California High-Speed Train Project

Request for Proposal for Design-Build Services

RFP No.: HSR 11-16
Design Variance Report

06/29/2012 ADDENDUM 3 - RFP HSR 11-16

**CALIFORNIA HIGH-SPEED TRAIN PROJECT
SIERRA SUBDIVISION**
PACKAGE 1A
TRACK GUIDEWAY
PLAN AND PROFILE
STA. 10862+00 TO STA. 10890+00

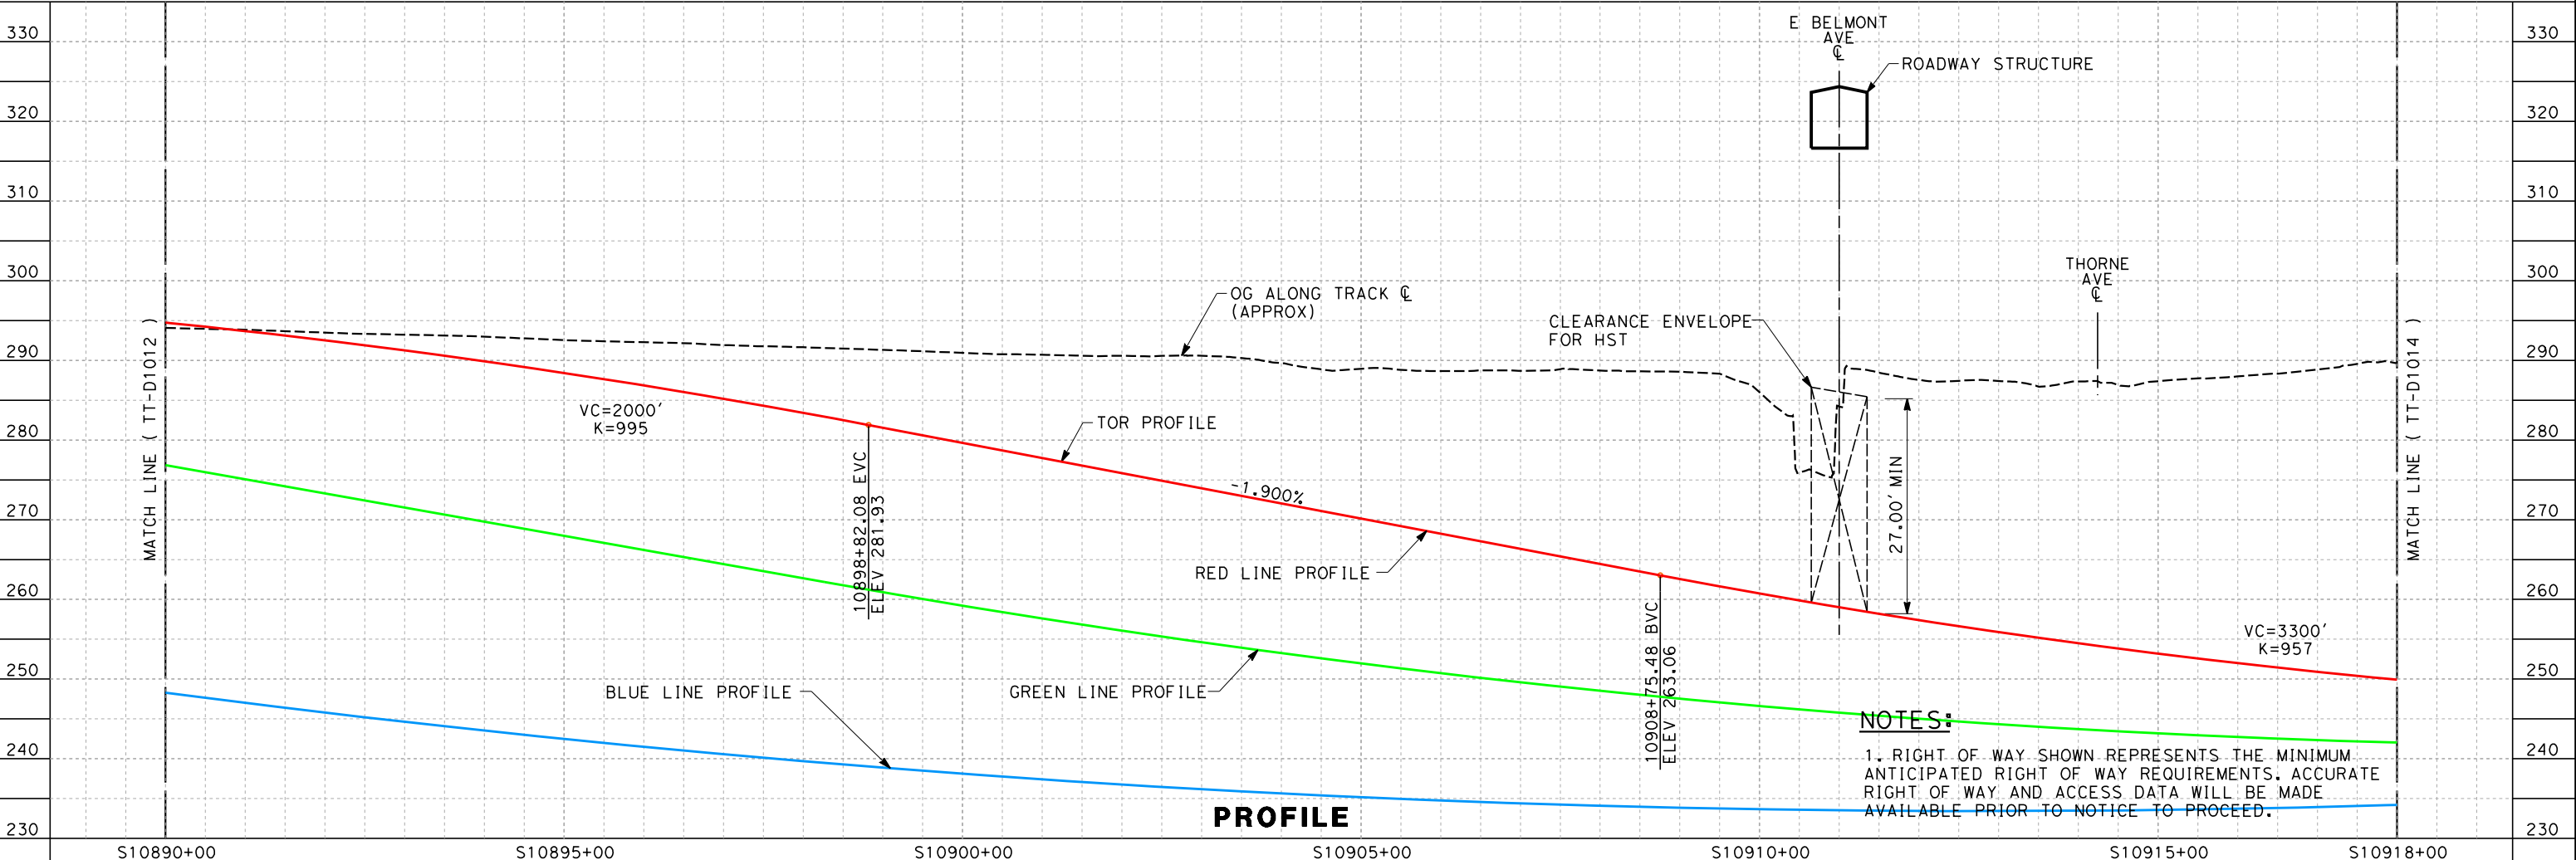
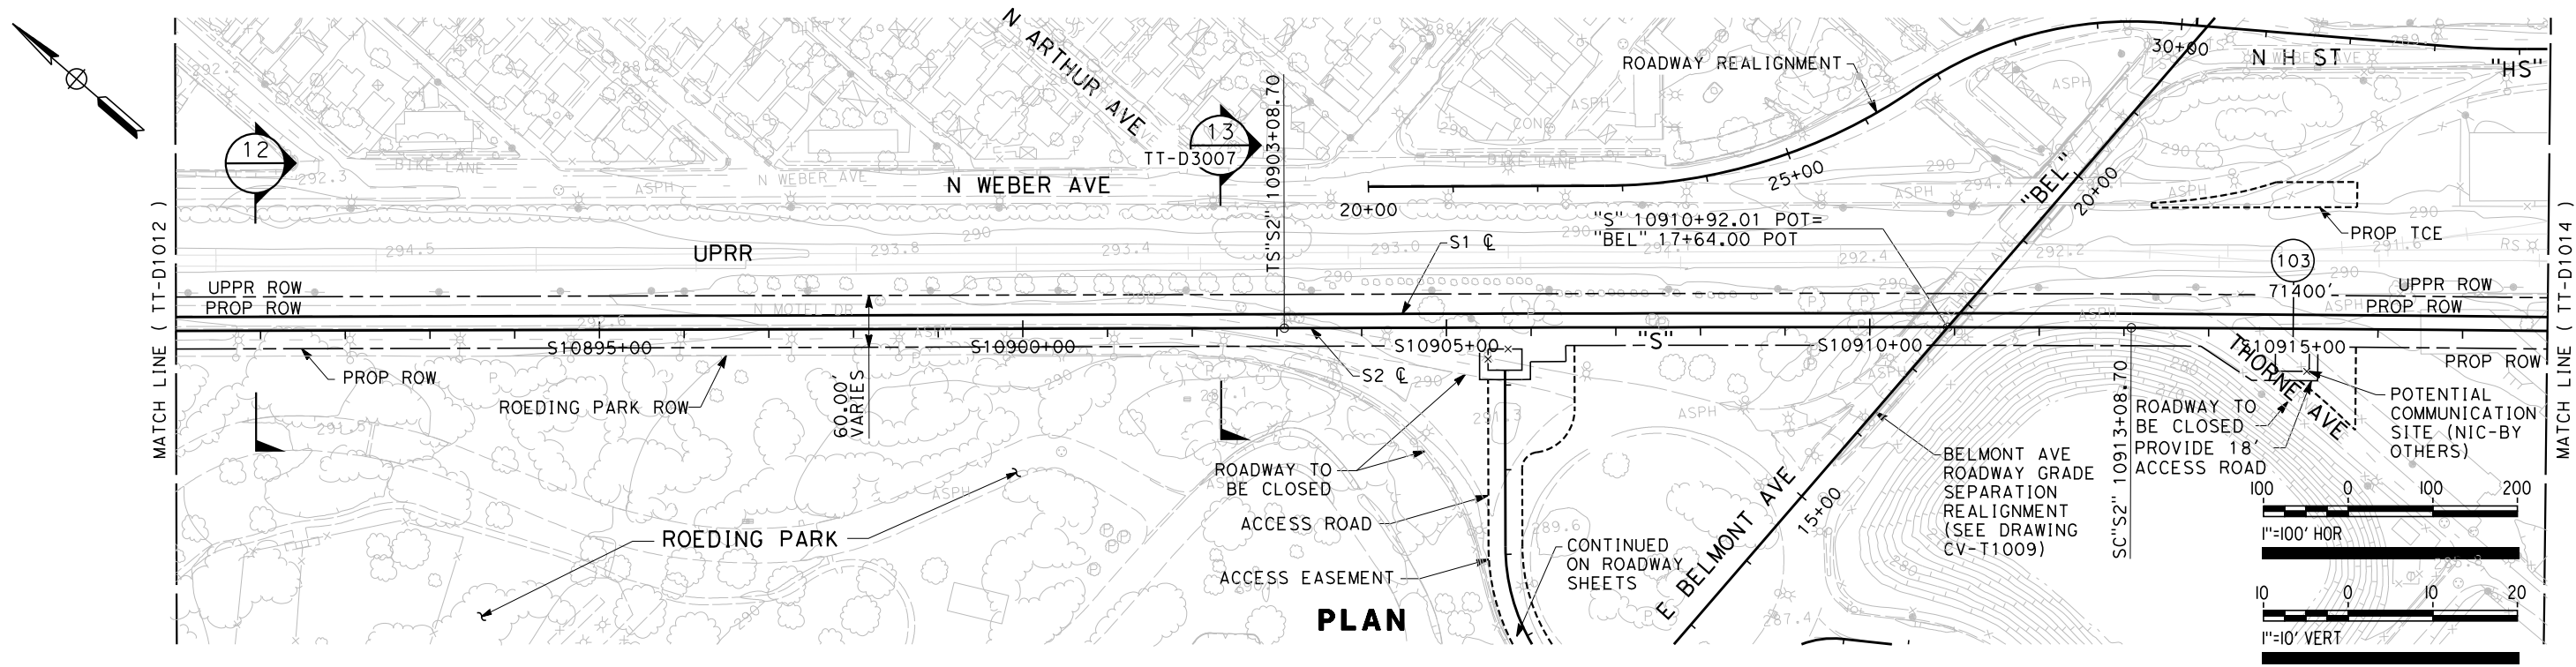
JUSTIFICATION FOR VARIANCE	The proposed design (red line — within exceptional alignment criteria at 220mph) minimizes the extents of trench and the distance between the

<p>proposed station and crossovers.</p> <p>The trench is 7,940ft long with a maximum depth of 42ft. The vertical curves are 2,000ft and 3,300ft long, respectively, and are approximately midrange between minimum criteria and exceptional criteria. The connecting straight meets minimum criteria.</p> <p>The distance between the station and the crossovers requires a design variance and will be made worse by the minimum (green line) and desirable (blue line) vertical alignments.</p> <p>Options for a 220mph desirable vertical alignment and a 220mph minimum vertical are shown in Appendix A. Significant differences to the proposed scheme are detailed below.</p> <p>Impacts of the 220mph desirable trench (blue line):</p> <p>A 220mph alignment that meets the desirable criteria would also allow for 250mph at minimum criteria.</p> <p>The total length of trench is 11,680ft with a maximum depth of 54ft. The crossovers are moved a further 3,060ft away from the station. This significantly worsens the crossover to station distance design variance.</p> <p>Impacts of the 220mph minimum trench (green line):</p> <p>The total length of trench is 9,700ft with a maximum depth of 48ft. The crossovers are moved a further 1,410ft away from the station. This worsens the crossover to station distance design variance.</p> <p>The preceding vertical curve at STA 10836+14 is moved north 1,400ft to create sufficient length for the crossovers. This has no significant impact.</p>

PROPOSED ALTERNATIVE DESIGN REQUIREMENT	<p>The proposed 220mph exceptional (red line) alignment represents a balance between achieving the minimum criteria and minimizing crossover to station distance and trench length.</p>

Summary of options:		
	Option	Speed (mph)	Length (ft)
	Blue	220	VC1=2400
			STR=1475
			VC2=5300
	Green	220	VC1= 2500
			STR=858
			VC2=4350
	Red	220	VC1= 2000
			STR=993
			VC2=3300
Overlap of vertical curve and horizontal spiral:			
<p>The location of the vertical curve is constrained by the requirement to pass under the existing structure at SR-99, the proposed Dry Creek culvert and the SJVR. The overlap between the elements is approximately 3,440ft for the red line and 4,000ft for the blue and green lines. Extending the straight approaching the station back through the horizontal curves and spirals would create a trench in excess of 100ft deep. This is shown by an orange dashed line in the appended drawings. This is considered unreasonable.</p>

Sketch 1

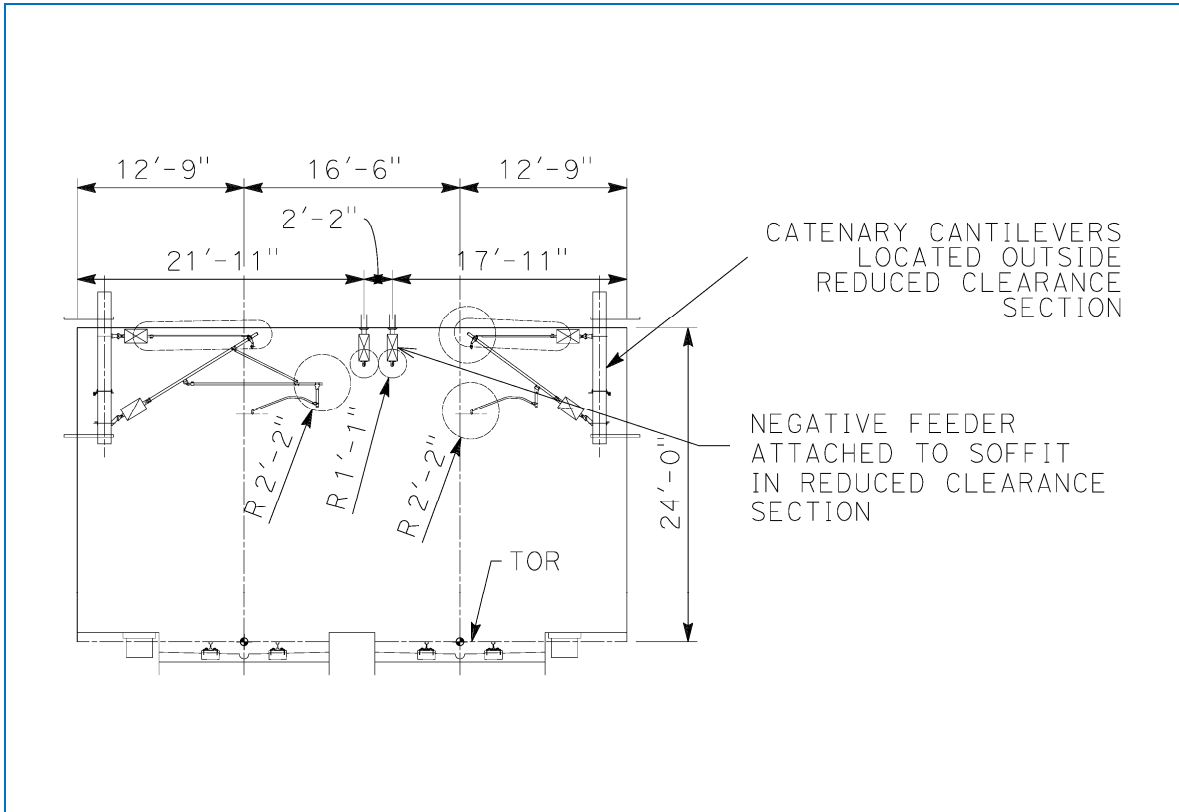
<p>The OCS equipment will be the same as required by existing structures on the route.</p> <p>The longitudinal negative feeder wire could be placed inside the cantilever with a minimum electrical clearance of 1ft 5.4 inches (440 mm).</p> <p>At the support the feeder wire does not have dynamic movement.</p> <p>Further electrical clearance can be achieved by placing the longitudinal feeder wire in the middle of the tracks, supported from the HST cover slab.</p> <p>This structure is located within a reverse horizontal spiral and vertical sag curve. This is not expected to present any significant issues.</p> <p>The alignment speed is 220mph.</p> <p>The 60 inch storm drain and the 30 inch sewer line would need to be supported across the trench using an external structure (pipe bridge). A number of options for this structure have been considered including a structural concrete encasement and steel tubular casing.</p> <p>Of these options, the required invert level can be achieved with a 1/2" wall thickness tubular steel casing of approx 80" diameter (for the 60" storm drain) with allowance for spacers and packing to permit withdrawal of the drainage pipe.</p> <p>Use of a concrete encasement would require further encroachment on the vertical clearance below 24'.</p> <p>In order to ensure minimum maintenance of the pipe crossings the casing would need to be protected against corrosion.</p> <p>3 options have been investigated</p> <ul style="list-style-type: none">• Paint system specification Blast clean to SSPC SP10 Primer Epoxy 2 mil

OCS SUPPORT LOCATION IN 27' HEIGHT CLEARANCE AREA

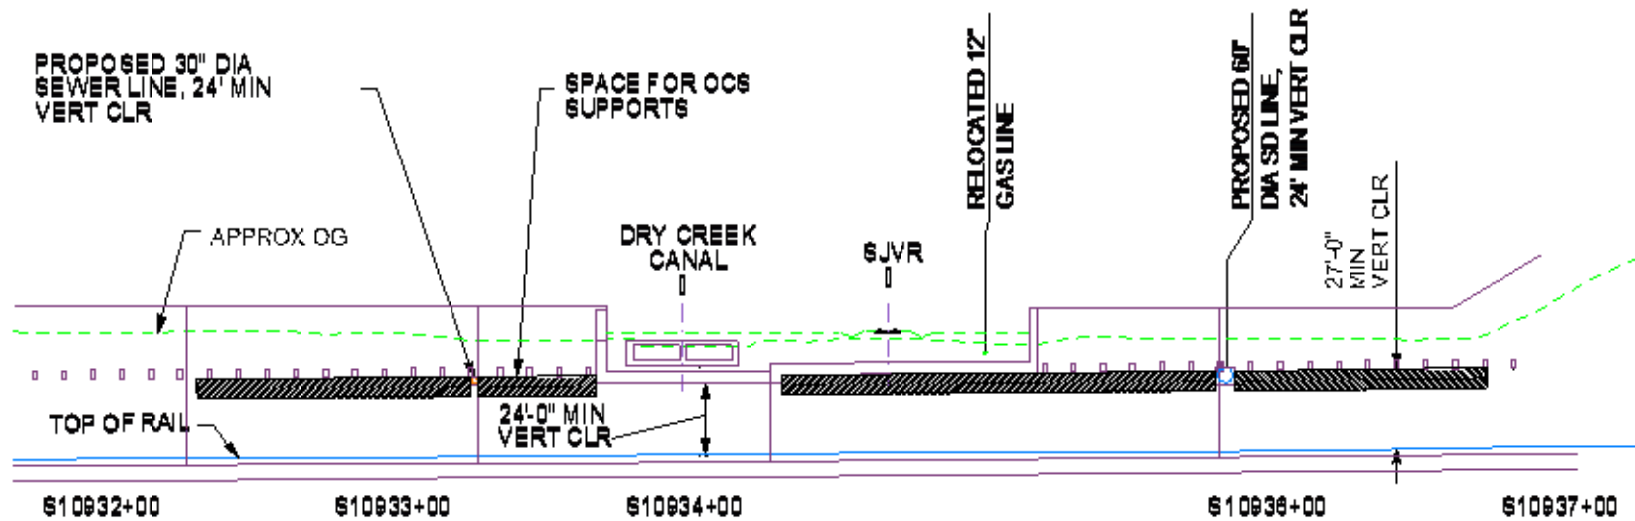
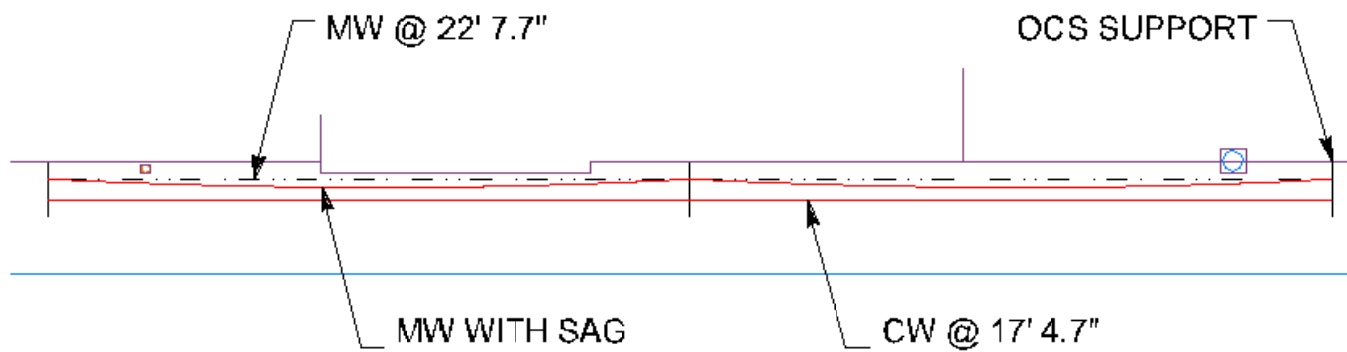
<p>PROPOSED ALTERNATIVE DESIGN REQUIREMENT</p>	<p>The OCS equipment will be required to be designed such that that no supports are located under the 30-inch sewer line, the Dry Creek culvert or the 60-inch storm drain (see OCS sketches in Appendix A).</p> <p>This is achievable as the contact wire through the section is designed at 17ft 4.7 inches (5300 mm) and with a system height of 5ft 3 inches (1600 mm) results in the messenger wire being 22ft 7.7 inches (6900 mm) at the support structure.</p> <p>Given the above, in the worst case situation with the OCS structure adjacent to any of the three low clearance areas, the clearance from them to the messenger wire would be 14.3 inches (363 mm), which exceeds the required normal static clearance of 1ft 0.6 inch (320 mm).</p> <p>In reality the static clearance will be greater as the messenger wire will sag due to its self weight and that of the contact wire and hangers.</p>
